ECN/PCN No.: M1390

For Manufacturer		
Product Description: 10/100 Base-Tx Single Port, Traditional SMD LAN Transformer	Abracon Part Number / Part Series: <p style="text-align: center;">ALANS100X1</p>	<input type="checkbox"/> Documentation only <input checked="" type="checkbox"/> Series <input checked="" type="checkbox"/> ECN <input type="checkbox"/> Part Number(s) <input type="checkbox"/> EOL
Affected Revision: <p style="text-align: center;">B</p>	New Revision: <p style="text-align: center;">C</p>	Application: <input type="checkbox"/> Safety <input checked="" type="checkbox"/> Non-Safety

1: 12-pin

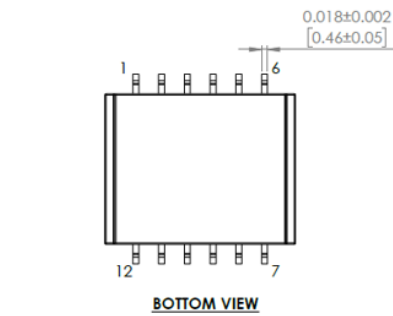
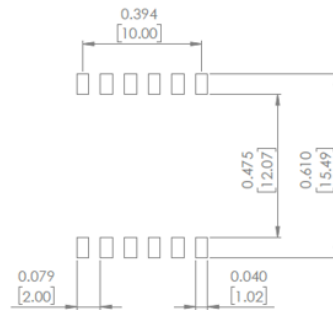
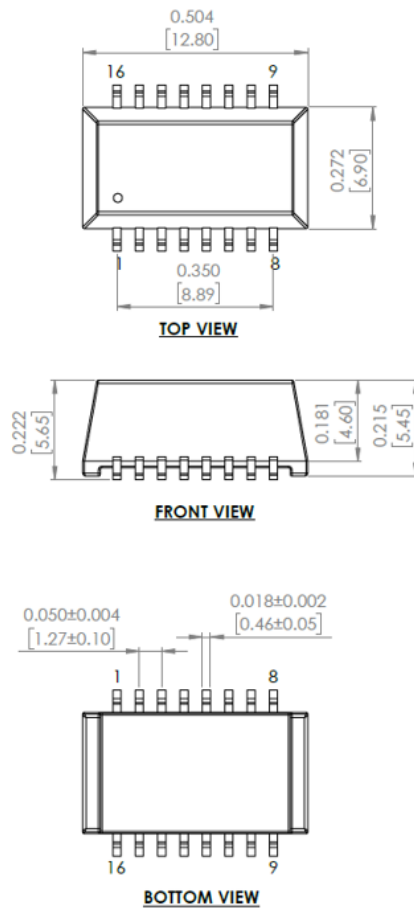
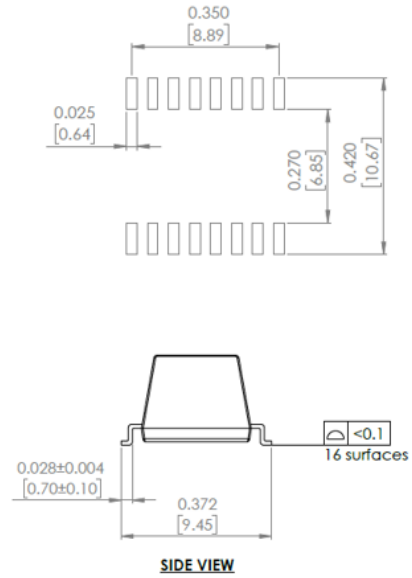
Moving to new production line. Removing unpopular larger 12-pin devices from series. Note change in pcs/reel.

The following device have been EOL'd:

ALANS100X1-1E10

ALANS100X1-1E30

ALANS100X1-1E02

ALANS100X1-1E00

ALANS100X1-1E82
